**ADDENDUM NUMBER ONE
TO
CHESTNUT MOUNTAIN PARK MAIN ENTRANCE - PHASE 2 STREAMBANK REPAIRS
CANTON, NORTH CAROLINA**

This Addendum Number ONE is issued this nineteenth day of October 2026, to all parties who hold a set of Bidding Documents for the project entitled: "Chestnut Mountain Park Main Entrance - Phase 2 Streambank Repairs". This Addendum No. 1 shall become part of the Contract Documents and its receipt shall be acknowledged on the Bid Form (Article 3.01) at the time of bidding. Bidders shall include all costs associated with the revisions described herein in their Bid. No separate payment will be made except as provided in the Bid Schedule.

PROJECT NO. 25.03006

G-002

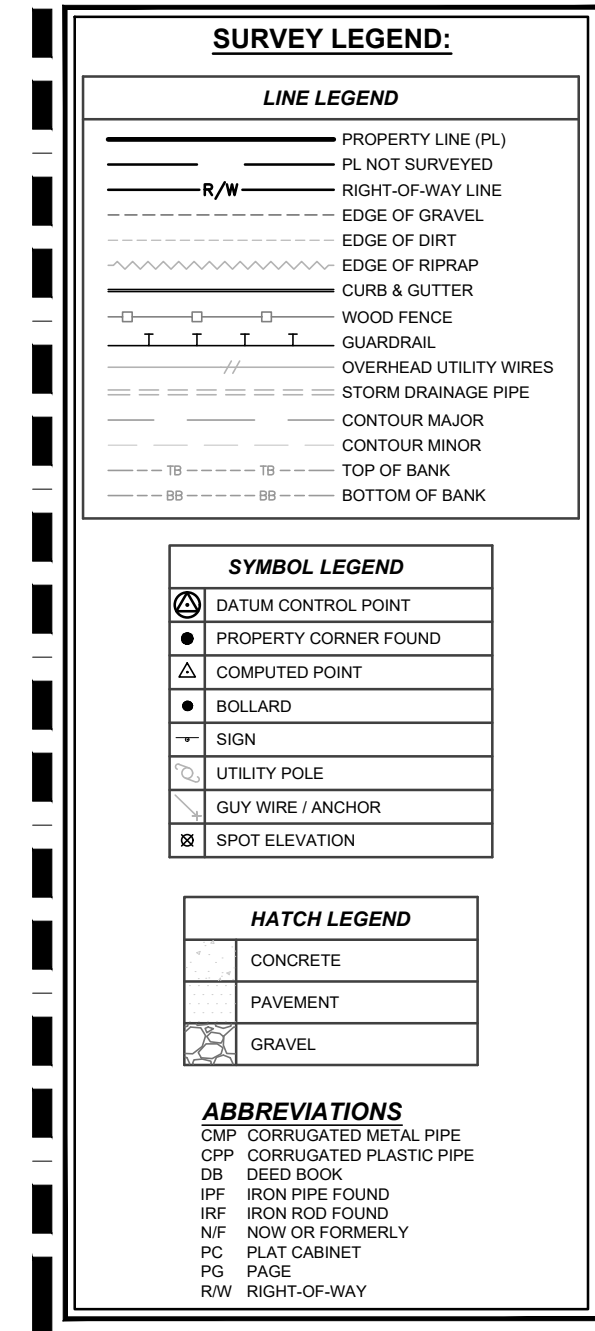
- d. Sheet G-002 adds an Erosion Control Maintenance Plan, final-phase removal of temporary measures, and the NCDOT Special Provision 38 requirement that erosion and traffic control devices be in place before work in the US 19-23 right-of-way.

C-101

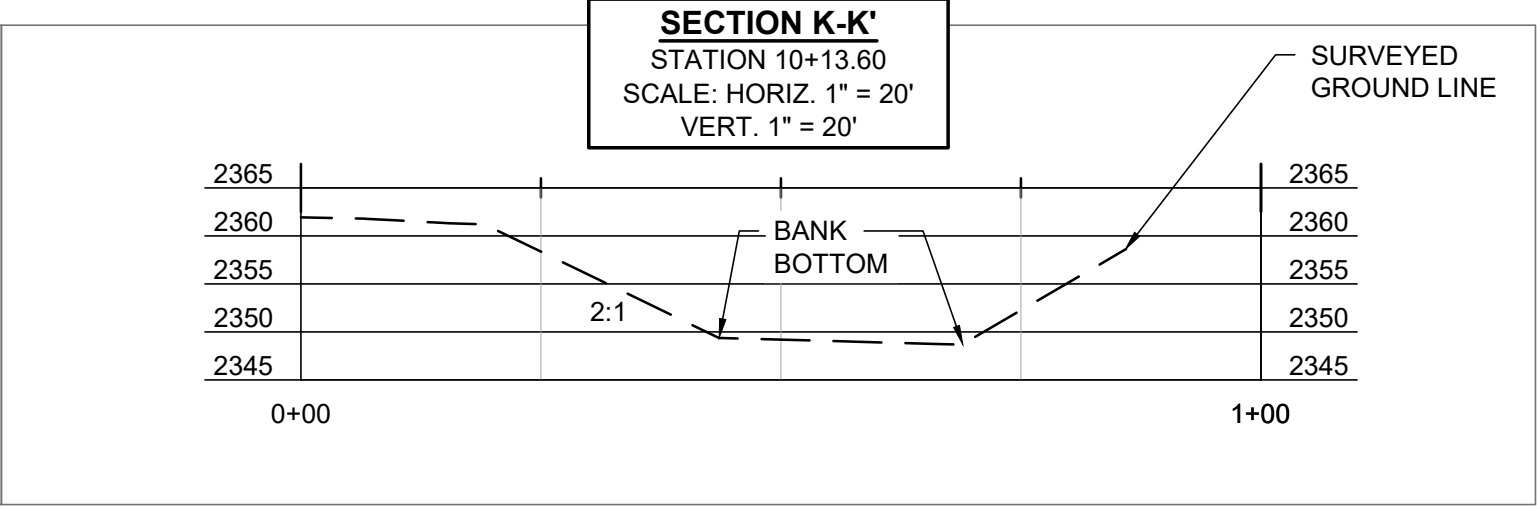
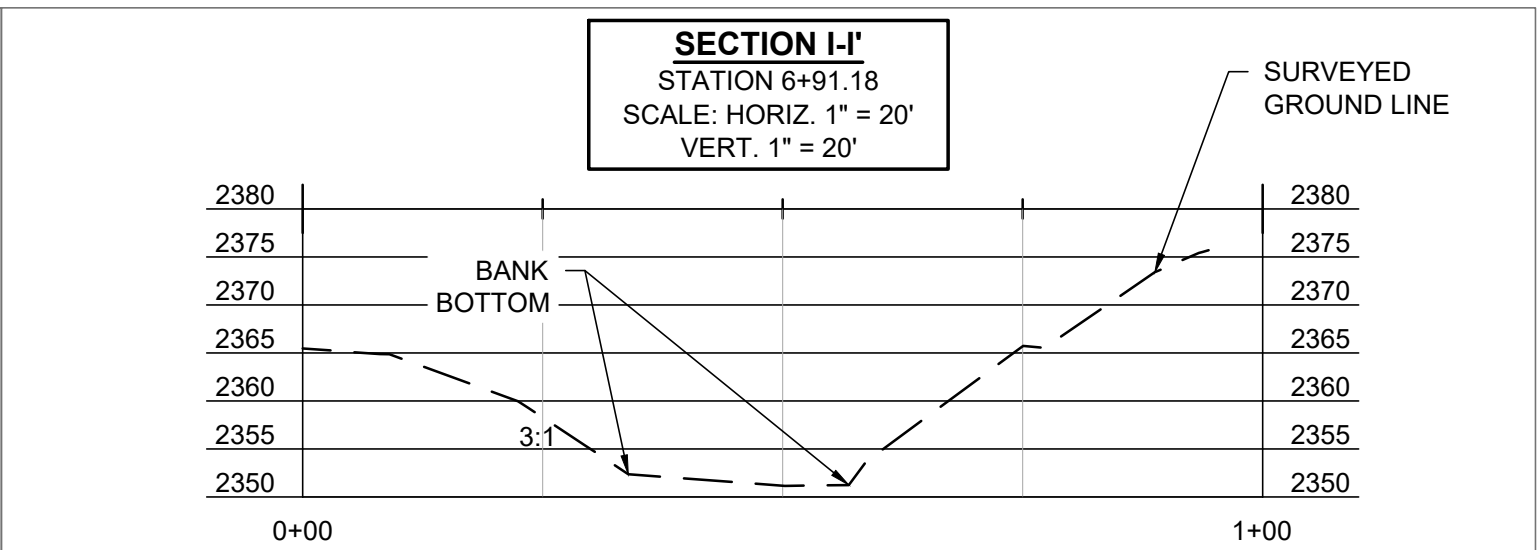
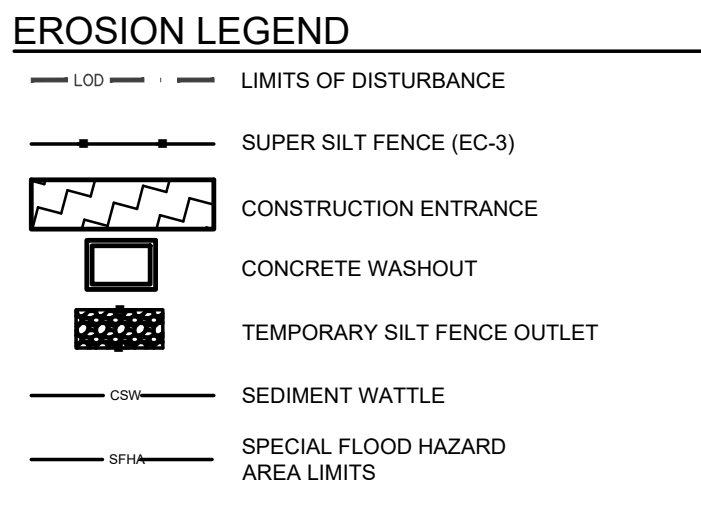
- a. The silt fence along Hominy Creek is changed to super silt fence (Detail EC-3, Sheet C-500): run SF-1 at Area 1 (approximately 174 LF, Sheet C-101) and run SF-2 at Area 2 (approximately 555 LF, Sheets C-102 and C-202), approximately 730 LF total. Super silt fence is used in place of double row silt fence because of the limited space between the work and the creek.

- b. Sediment wattle rows (Detail EC-22, Sheet C-500) are shown upslope of the super silt fence: 127 LF at the new top of bank in Area 1 (Sheet C-101), with the ends turned upslope, and 447 LF and 229 LF rows on the regraded Area 2 bank (Sheets C-102 and C-202).

- c. The dewatering filter bag on a stone pad (Detail M-77) is located on Sheet C-101 (Erosion Control Note 1). All E&SC measures are located inside the limits of disturbance shown on Sheet C-100.
